Contract #: 04-0120F4Cty: SF/ALA Rte: 80 PM: 13.2/13.9File #: 69.25B**QUALITY ASSURANCE -- NON-CONFORMANCE REPORT****Location:** Changxing Island, Shanghai, P.R. China**Report No:** NCR-000736**Prime Contractor:** American Bridge/Fluor Enterprises, a JV**Date:** 18-May-2010**Submitting Contractor:** Zhenhua Port Machinery Company, Ltd (ZPMC), Changxing Island**NCR #:** ZPMC-0699**Type of problem:****Welding****Concrete****Other****Welding****Curing****Procedural****Bridge No:** 34-0006**Joint fit-up****Coating****Other****Component:** Crossbeam 14 Bottom Panel**Procedural****Procedural****Description:**

Reference Description: ZPMC performed Heat Straightening without prior Engineer's approval and without following the ZPMC internal HSR1 document

Job Name: SAS Superstructure

Subject: NCR No. ZPMC-0699

Component: Crossbeam 14 Bottom Panel

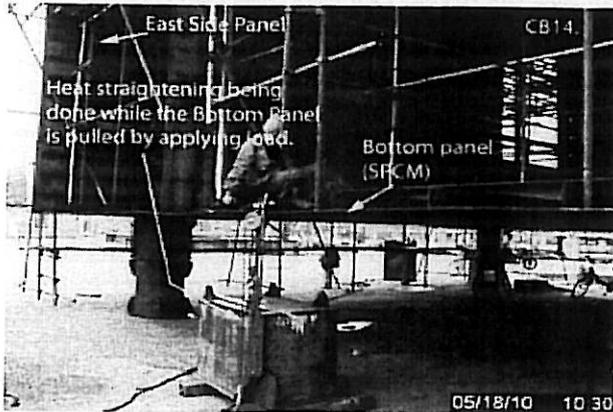
During Quality Assurance (QA) random in-process observations of the fabrication of crossbeam CB14, this QA inspector observed the following issue:

- ZPMC personnel performed heat straightening to the bottom panels BP203A and BP201A in Crossbeam 14.
- ZPMC personnel did not follow the heat straightening report presented by ZPMC Quality Control (QC) on site. According to ZPMC Heat Straightening Record (HSR) identified as HSR1 (B)-8472, the straightening would be performed using an oxygen/acetylene torch. ZPMC personnel were straightening the material using heat and a hand operated winch (come-along) attached to a weight placed on some timber on the ground. The amount of pull down force being applied is not known. Also, the use of the come-along and weight or any other mechanical force is not mentioned in the HSR.

- The out of flatness was measured to 16mm per 1000mm, which requires a HSR with prior Engineer's approval.
- The bottom panel of the crossbeam is identified as Seismic Performance Critical Member (SPCM).

- Bottom panel material thickness is 12mm.

Heat Straightening Record(HSR1)

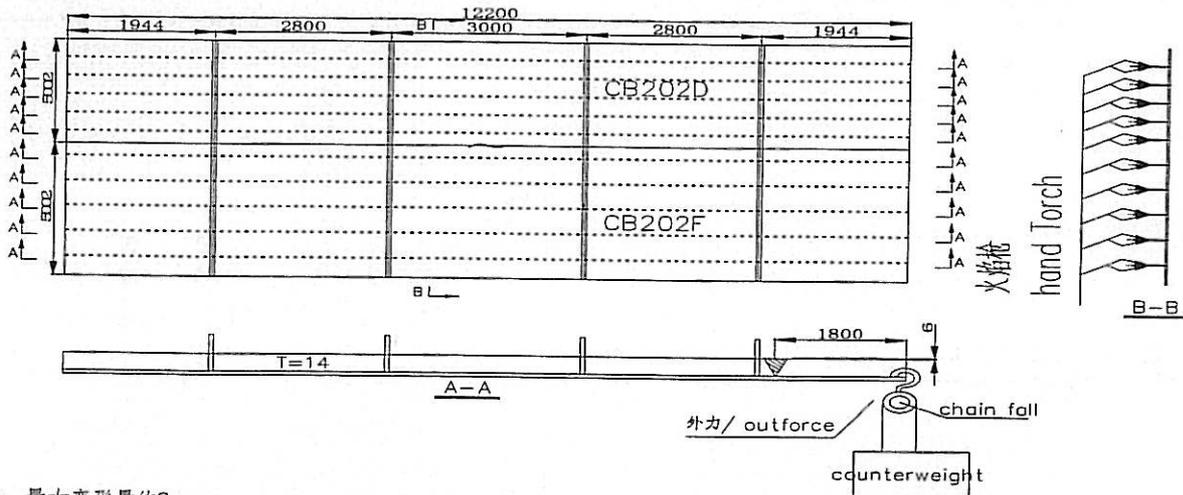
The revised heat straightening report detailed the methods used during repairs. The NDT is acceptable. However, the report should have been submitted for Engineer's approval in the first place. In addition, the quality management issue has not been addressed.

缺陷去除方法(Defect Removal Method): Flame Straightening by oxygen acetylene 运用氧乙炔进行校火

后续NDE(Post-Removal NDE): After finishing heat straightening, the weld of the heat area shall perform NDT according to the approved shop drawing 校火后, 根据图纸要求对热影响区域进行NDT检测。

注: 最大变形量约6mm.

NOTE: the max deformation is about 6mm.
